APPLICATION NO.	FILING DATE	FIRST NAMED INVENTOR	ATTORNEY DOCKET NO.	CONFIRMATION NO.
09/437,296	11/09/1999	MICHIO YAMAJI	991283	7789

Office Action Summary

DETAILED ACTION

Claim 1 is rejected under 35 U.S.C. 103(a) as being unpatentable over US patent 5967489, Nakazawa et al in view of US patent 5505464, McGarvey.

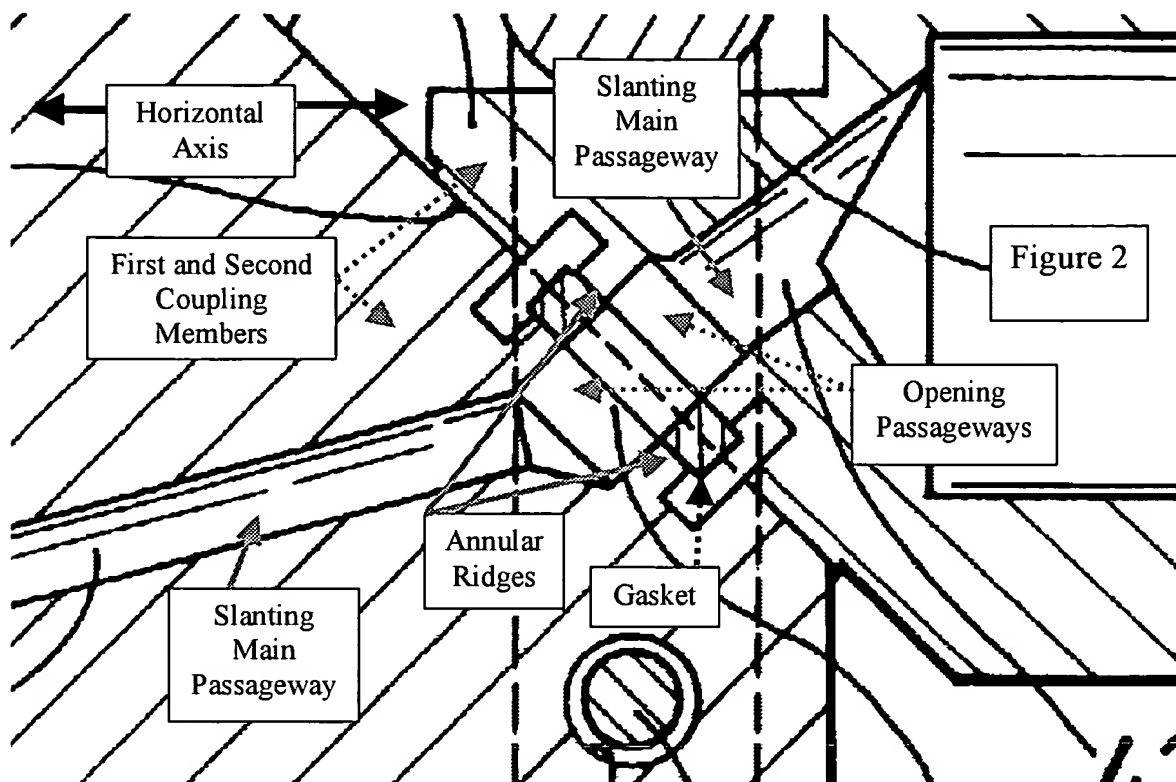
In regards to claim 1, in figure 2 below, Nakazawa et al discloses a fluid coupling comprising first and second coupling members having respective gasket holding annular ridges on butting end faces thereof; and

an annular gasket interposed between the first and second coupling members, wherein each coupling member has a fluid channel comprising an opening passageway orthogonal to the butting end face thereof, and a slanting main passageway communicating therewith, the opening passageway having a diameter equal to the inside diameter of the gasket holding annular ridge, and

the gasket holding annular ridges are in contact with the gasket at its radial midportion so as (capable) to relieve the inner peripheral portion of the gasket from stress concentration and wrinkles.

Nakazawa et al does not disclose the gasket holding annular ridges being rounded as to be in contact with the gasket only at its radial midpoint. In Figure 4, McGarvey teaches gasket holding annular ridges (36, 38) being rounded as to be in contact with the gasket (12) only at its radial midpoint to produce a minimum dead zone volume condition (col. 1, lines 45-64). As McGarvey relates to face-seal fitting employing a metal gasket, it would have been obvious to one having ordinary skill in the art the time the invention was made to fabricate rounded gasket holding annular ridges as to be in contact with the gasket only at its radial midpoint to produce a minimum dead zone volume condition, as taught by McGarvey.
